Reliability Analysis Update

PJM – Mid-Atlantic

Subregional RTEP Committee – PJM MA

February 12, 2026

Penelec Transmission Zone: Baseline Warren 115kV Breaker “NO.1 XFMR” Replacement

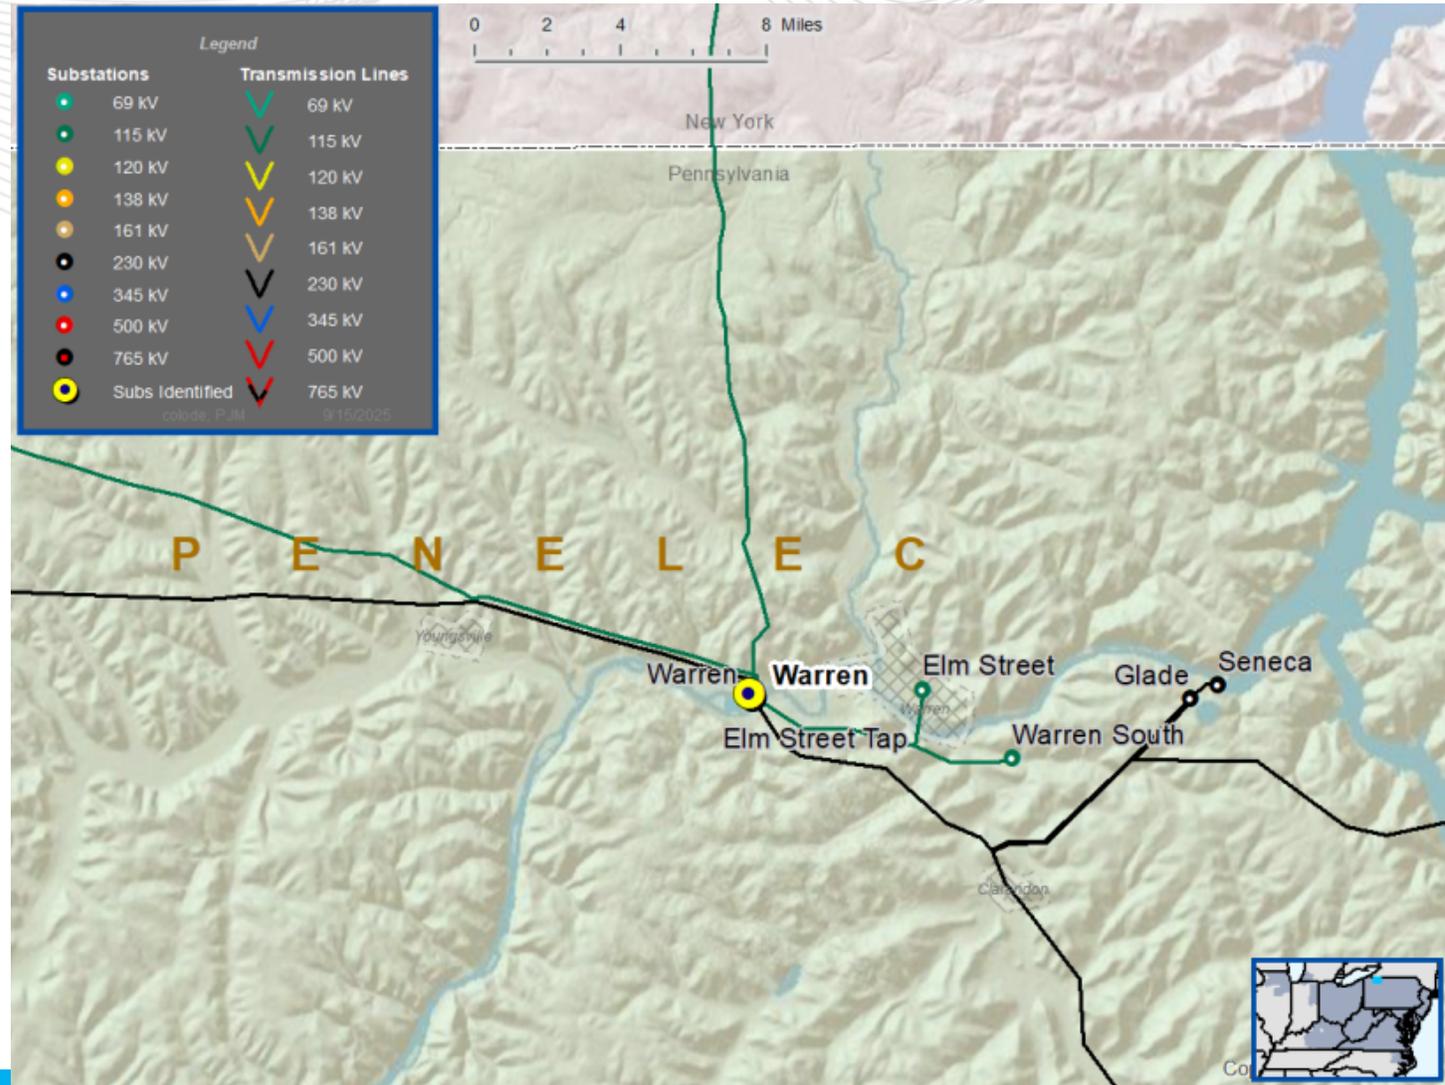
Cancellation of b3988.1

Original Proposed Scope:

Replace the over dutied Warren 115 kV circuit breakers “NO.1 XFMR” with a 40 kA circuit breaker.

Reason for Cancellation:

Breakers is a Distribution asset, not Transmission.
Breaker is not controlled by PJM

Rebuild the New Church - Piney Grove 138 kV line. (B3749)

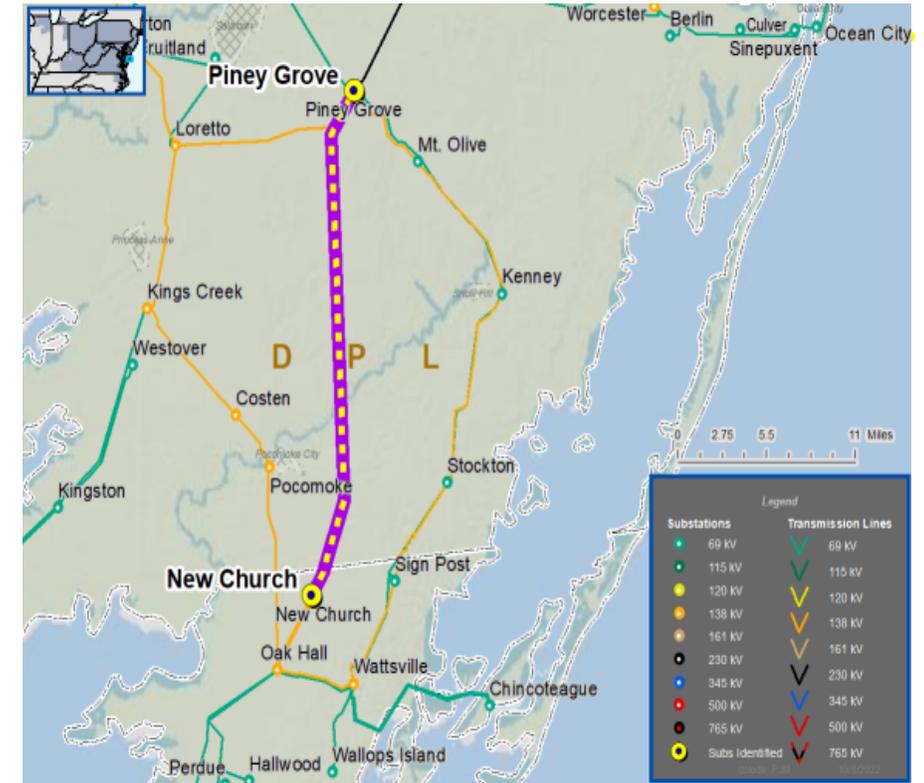
Problem Statement: The New Church – Piney 138 kV circuit overloaded for line fault stuck breaker contingency

Estimated Cost: \$63M \$77M

Reasons for Cost Increase:

- **Significant increase in access and matting scope (60% of cost increase):** The corridor includes wetlands, the Pocomoke River crossing, RTE species restrictions, and seasonal work limitations. These constraints materially increased temporary access requirements, including construction matting quantities, installation/removal effort, and longer durations in sensitive areas. Matting scope is now substantially higher than what was assumed in the original cost estimate.

- **Material cost escalation since 2022:** Steel monopoles, conductor (1590 ACSR Lapwing), OPGW, foundations, and associated hardware have all experienced notable price escalation since the original proposal. The current estimate reflects updated vendor pricing and long-lead material commitments consistent with today's market conditions

- **Estimate includes refined quantities:** After detailed engineering review, new cost estimate reflects finalized structure counts (steel monopoles replaced H-frames), foundation designs, constructability review, and more accurate labor and equipment assumptions than assumptions made at the original high-level planning stage.

- **Environmental, permitting, outage coordination impacts:** Increased construction duration and indirect costs due to permitting requirements across Maryland and Virginia, avian protection measures, and outage sequencing constraints.
